**AMENDMENTS TO THE DRAWINGS**

**REMARKS**

**FIG. 7D**

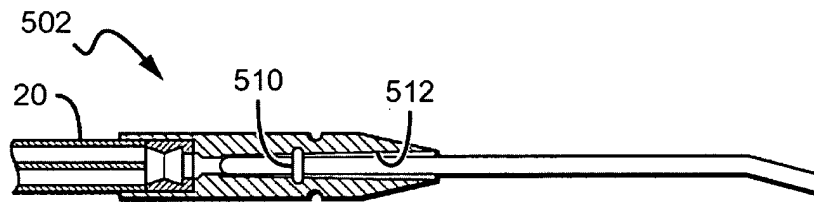
Second, the Examiner is incorrect in asserting that the claimed language does not match with the drawings. As the drawing below clearly shows, there is no inconsistency between the claim and specification disclosure pursuant to MPEP § 2173.03. In particular, the Examiner is conflating distal and proximal as shown below, and has mistaken tunneler 50 for catheter 20. Further, although believed by Applicant to be unnecessary, in the interest of compact prosecution, Applicant has included herein new FIG. 7D to show the features clearly described (*see* paragraph [0047], a section of which is reproduced below) in the instant specification with respect to elected species 7A-7C.

After the catheter is placed and the tunneler is positioned in the subcutaneous tunnel, the proximal end of the connector housing 502 is slid over the tip of the tunneler 50. A compression ring, such as O-ring 510, grips the tunneler tip, allowing the catheter to be withdrawn through the subcutaneous tunnel by pulling the connector 502 through to an exit site. As described above, a wall 512 defining a portion of the passageway proximal the O-ring may be tapered.

ANNOTATED SHEET SHOWING CHANGES

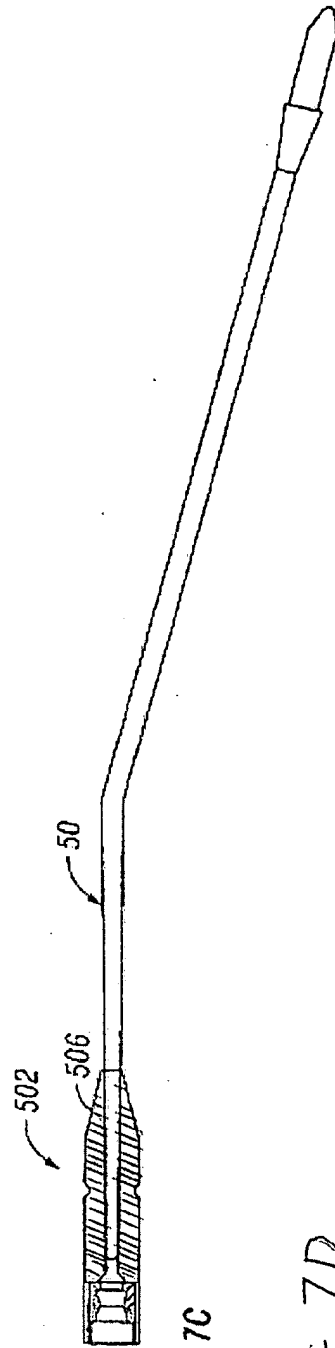
The attached sheet of drawings includes changes to FIGS. 7A-7C and the addition of new FIG. 7D.

Please amend FIGS. 7A-7C to include cross-hatching to more clearly show the components as in FIGS. 1-3.

Please add FIG. 7D to show an O-ring and a wall defining the proximal portion of the passageway proximal of the O-ring being tapered. Support for FIG. 7D can be found in the originally filed application at, for example, paragraphs [0042] and [0047].
